ORIGINAL

MODIFIED TO
REVISION B

REV NOTES, ADD TERM LEADER	SCALE:N/A	PROJECT:MRR		TITLE:NCE AUTOSW CONVERT A 2 B	
	DRAWN:JIM EXLER	LOC: NAMPA		DRG: ASWA2B-2	REVISION 1
	DATE: 10/12/21	JOB NO:823MR	AutoSW VerA PCB.dwg

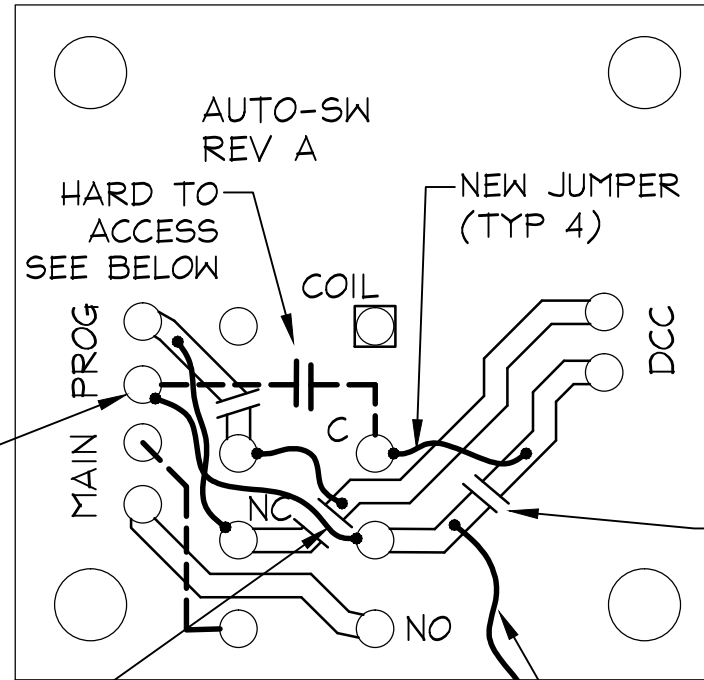
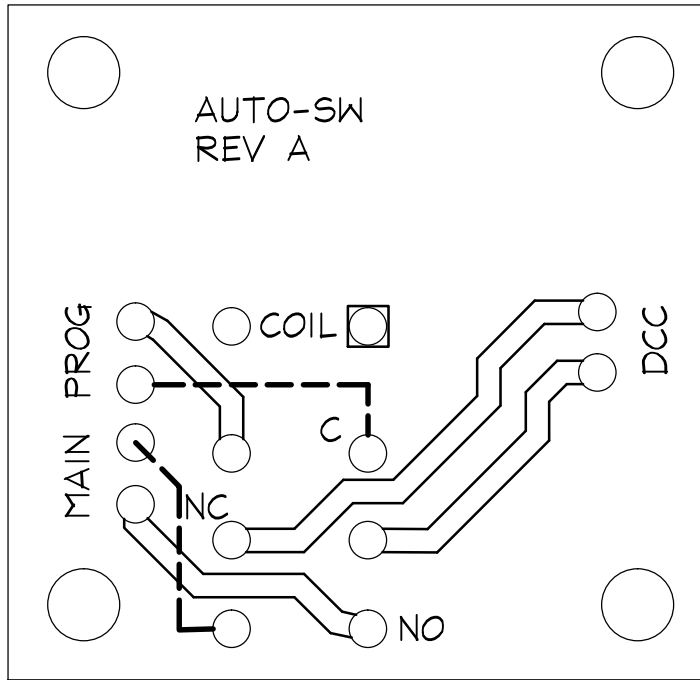
HARD TO
ACCESS
SEE BELOW

NEW JUMPER
(TYP 4)

CUT TRACE

ABANDONED TERM AND
JUMPER PER NOTES

LEAD TO REPLACE
ABANDONED PROG
TERMINAL

NOTES:
THE HIDDEN TRACE FROM THE C RELAY TERMINAL TO THE LOWER PROGRAM
TERMINAL CAN BE HIDDEN FROM VIEW BY THE TERMINAL BLOCK. IN LIEU OF
REMOVING THE TERMINAL BLOCK FOR ACCESS, YOU COULD ABANDON THAT
TERMINAL, AND INSTEAD OF THE JUMPER, CONNECT A WIRE FROM THE NC
TERMINAL WHERE THE JUMPER IS SHOWN AND CONNECT THE OPPOSITE END TO
THE WIRE THAT WOULD HAVE GONE TO THE ABANDONED TERMINAL.
IT IS NOT WORTH POSSIBLE DAMAGE TO THE BOARD TO SAVE THIS TERMINAL.
